Project No.: R.082215.001

October 11, 2018

END OF ADDENDUM NO. 10

Photo #9 View of millwork inside program room E15 to be demolished for new cells

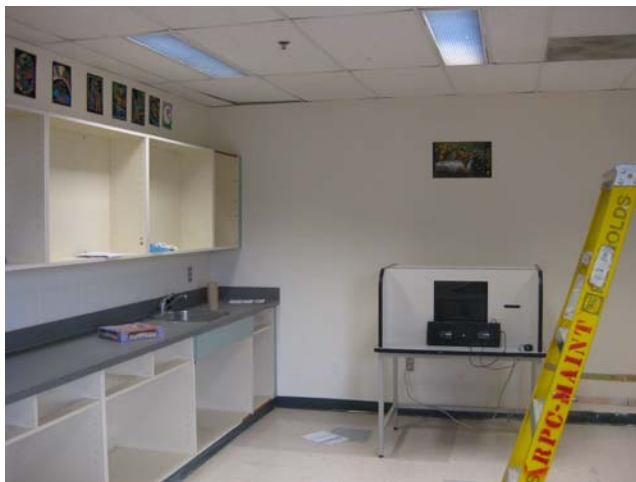
ITEM #	QUESTION	ANSWER
1	Provide photos of hallways, existing walls, ceilings, doors, chainlink fence, etc. to be demolished	Refer to the attached 4 pages of site photos
2	Provide specification or description of the additional speakers	<i>The new speakers should be 25 VRMS or 70VRMS operation up to 8W(wattage taps from 0.125W to 8W). Speaker back shall be sealed and construction shall be vandal-resistant. Speaker shall be designed for maximum output at a minimum wattage across the frequency range of 400Hz to 4kHz. Speaker shall be white in colour.</i>  <i>Standard of Acceptance is Bosch(Wheelock) ET-1010-W</i>
